**CLINCH RIVER
BREEDER REACTOR PROJECT**

**PRELIMINARY
SAFETY ANALYSIS
REPORT**

VOLUME 21

PROJECT MANAGEMENT CORPORATION

Figure Q241.45-2 Fuel Restructuring Patterns (Channel 2)

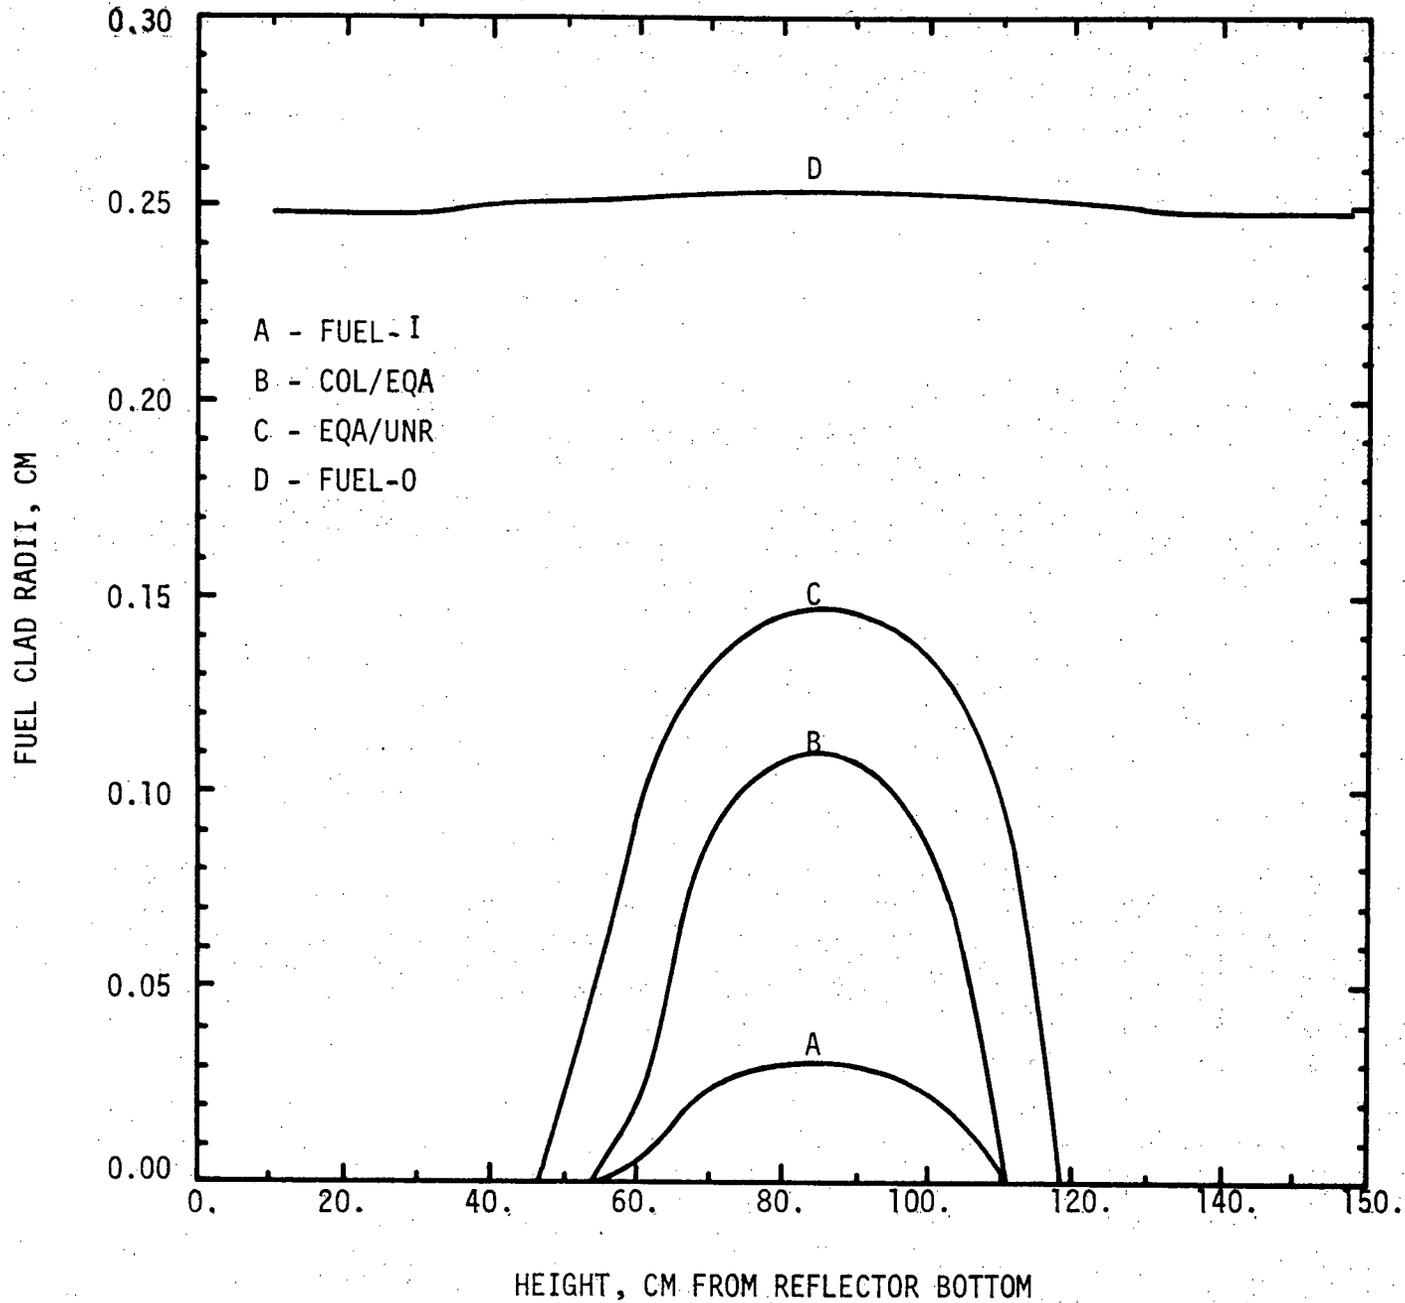
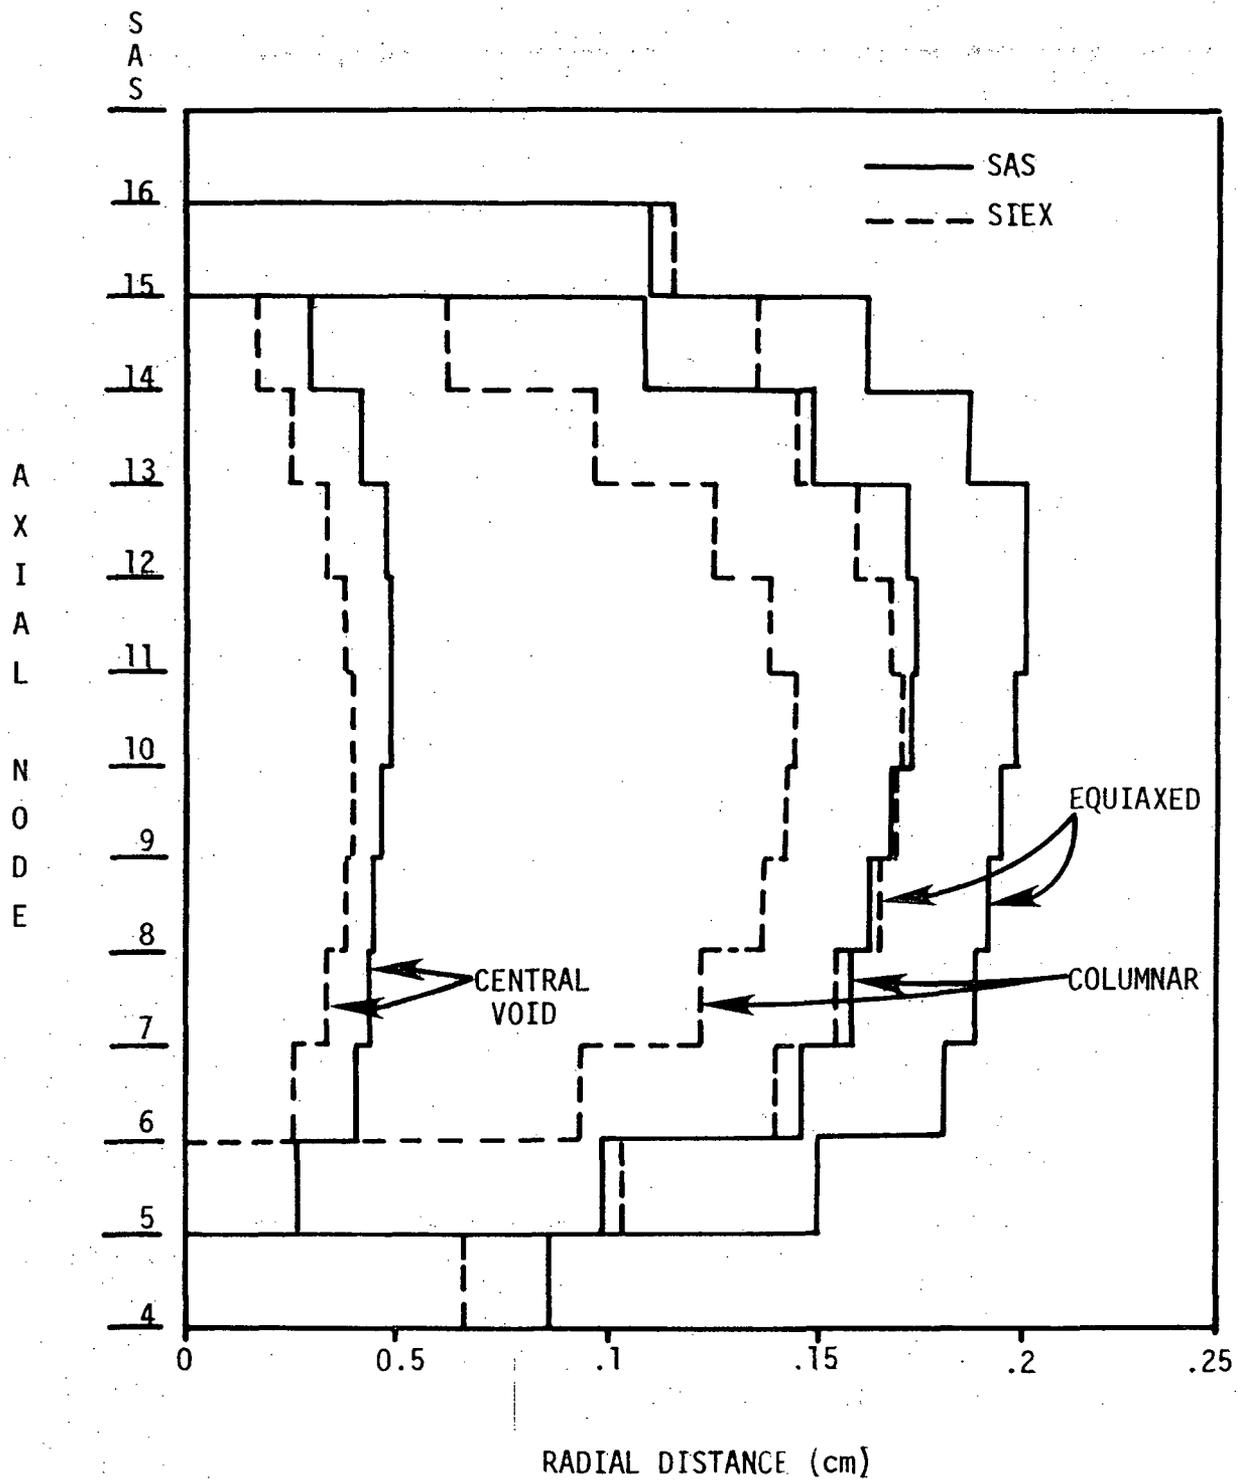
Two studies have been made in which fuel restructuring was one of the parameters considered. The first was a comparison of a high gap conductivity SAS3A model with that used in the CRBRP HCDA analysis (see response 160 to Q001.451); the second was a comparison of the experimentally correlated SIEX code and the SAS3A code (see the response to Q001.469). The restructuring patterns from these studies are shown in Figures Q241.45-1 and 2. It can be seen from these figures that the SAS3A model used in the Project's HCDA analysis predicts the greatest amount of restructuring. However, as noted in the response to Q001.469, the comparison of SAS3A results and the results from SIEX, COBRA-3M and damage parameter analyses indicate the steady state uncertainties will not significantly affect the overall accident scenario or energetics. 160

Figure Q241.85-1. FCTT Test Results with Clad Sections from Irradiated Fuel-Pins as Compared to In-Transient Plenum Condition for CRBRP Fuel-Pins

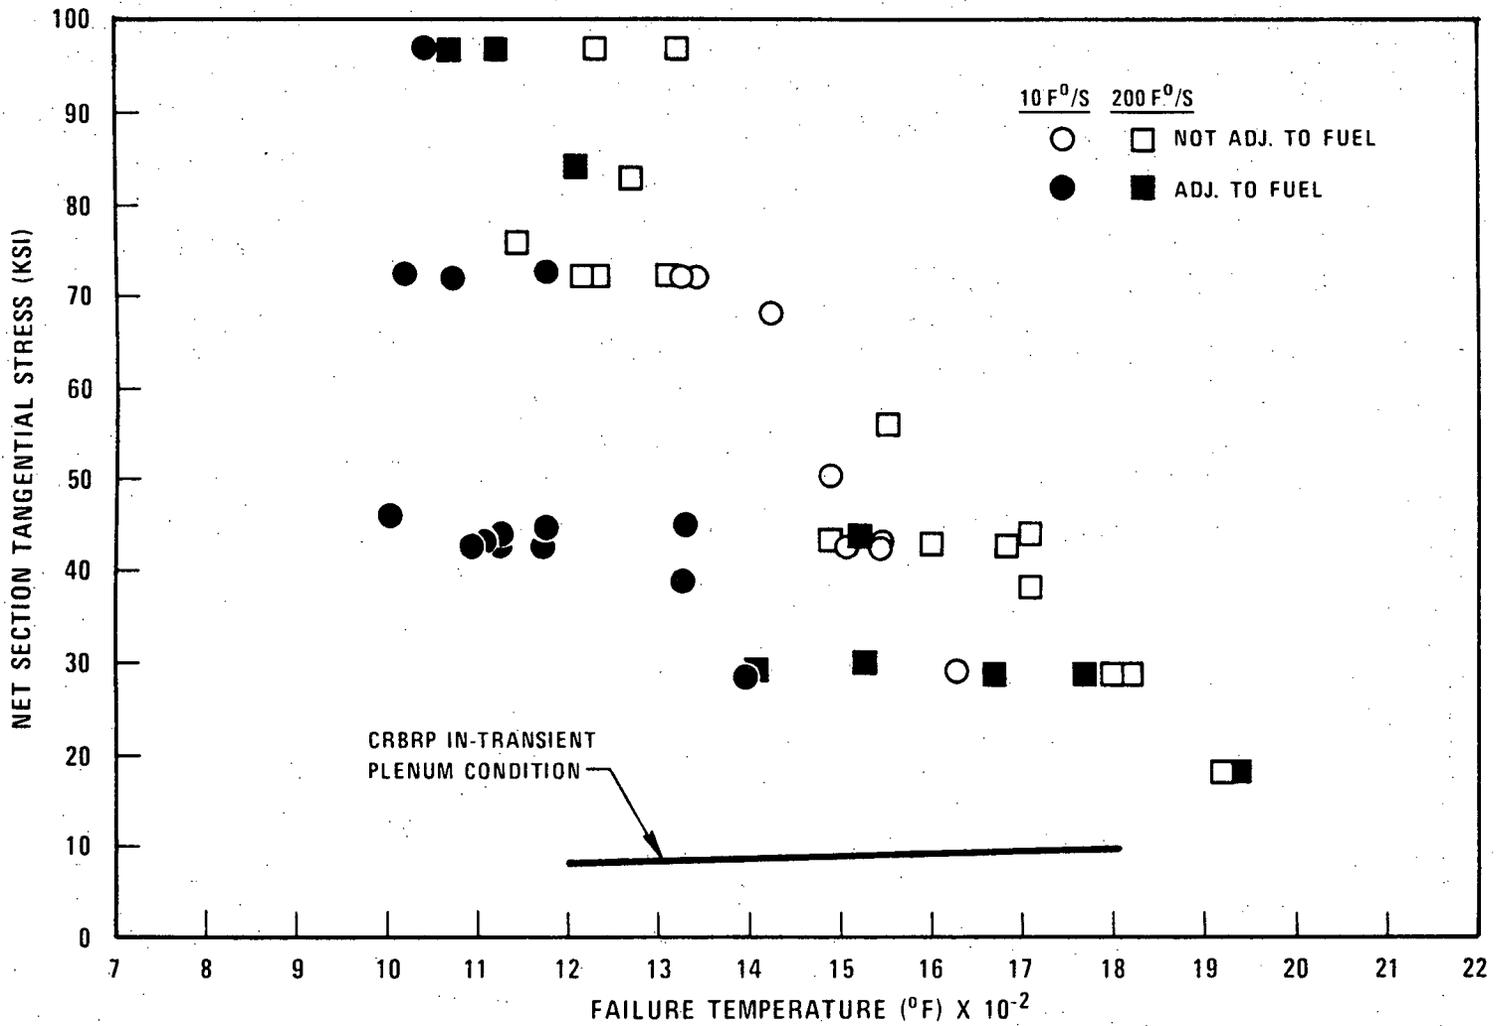
This question is addressed in Part I of the response to Question 241.85; in particular, see Figure Q241.85-1 in that response. This figure clearly shows that the conservatively estimated CRBRP fuel pin cladding stress during a design basis undercooling emergency event at 411 EFPD is well below FCTT failure data obtained with clad sections from fuel pins from NUMEC F, PNL-10 and PNL-11.

In addition to the erroneous interpretation of the CRBRP temperature limits, the Reference Q241.85-1 interpretation of the FCTT data is inaccurate; specifically, Reference Q241.85-1 ignores stress as a parameter in these rupture tests. Indeed, when the stress levels of the tests are considered, the results show the ability of the CRBRP fuel pin to withstand undercooling emergency events.

The FCTT failures referred to in Reference Q241.85-1 were achieved at temperature-stress combinations that are well beyond those expected in the CRBRP fuel-pins, even at design lifetime (i.e., 411 Effective Full Power Days, EFPD). To illustrate this point, a conservative estimate of the tangential stress at 411 EFPD, as derived from gas pressure during a transient, is compared to the FCTT data in Figure Q241.85-1; these data are from Reference Q241.85-3. The line showing the CRBRP condition was computed assuming an initial (steady state) plenum temperature of 1200^oF and a pressure of 1000 psi. The pressure, and hence the stress, was taken to increase with plenum temperature, as might be the case during an undercooling event. As shown in Figure Q241.85-1, at comparable temperatures, the anticipated CRBRP condition is well below the FCTT failure condition. This figure also shows that for cladding stress below 20 ksi, failure temperatures much higher than 1600^oF have been recorded.
